# INSPECTOR'S NOTE TO PARTIES 29.4.22 VASTERN COURT, READING APP/E0345/W/21/3289748 OPEN SPACE EVIDENCE

## Policy, Amount, Type of Open Space

Figure 1. Section through overhang area

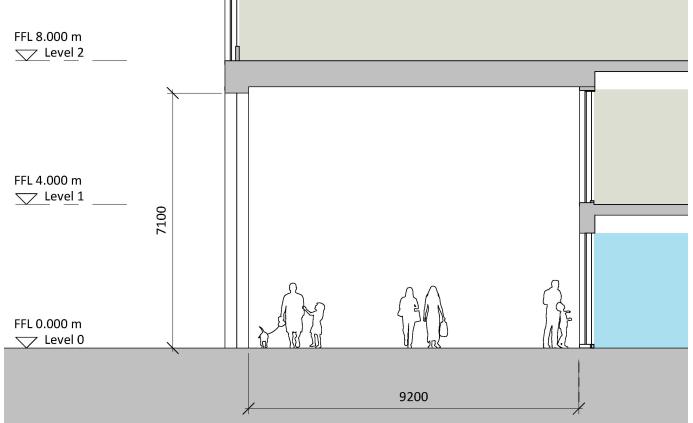
Paragraph 5.7 of Dr Jenkins' proof sets out that overhead intrusion into the open space area will restrict its use.

**Q3.** Could this overhang be designed to serve this purpose and still operate as a useful part of the open space?

The solar shading as referred to in Mr. Crawshaw's Proof of Evidence relates to the form of the buildings and the use of architectural features to reduce summer overheating. The overhang referred to is with respect to the whole building proposed to project out from the second floor upwards, rather than a specific individual structure.

The projection of the building would create an overly shaded area of open space that would neither provide a pleasant environment for enjoyment nor landscaping which would make a contribution to the energy efficiency of the development as a whole.

In order to be multifunctional, the open space should have been designed to benefit from natural daylight for significant parts of the day, otherwise maintenance and the ability to support green infrastructure would be heavily compromised.

The proposed overhang of Plot D will not compromise the use of the wider open space.

The distance from ground level to the underside of the overhang will be a minimum of 7m (and will be set back at a depth of 9 m). It is therefore a relatively small

area and importantly is south facing so would not be overly shaded. It clearly has the potential to serve as a useful part of the open space provision (Please see attached section and sun path analysis).

Is a section through the area of the overhang showing the overall generous scale of the space: Approximately 7 metres high and 9 metres deep
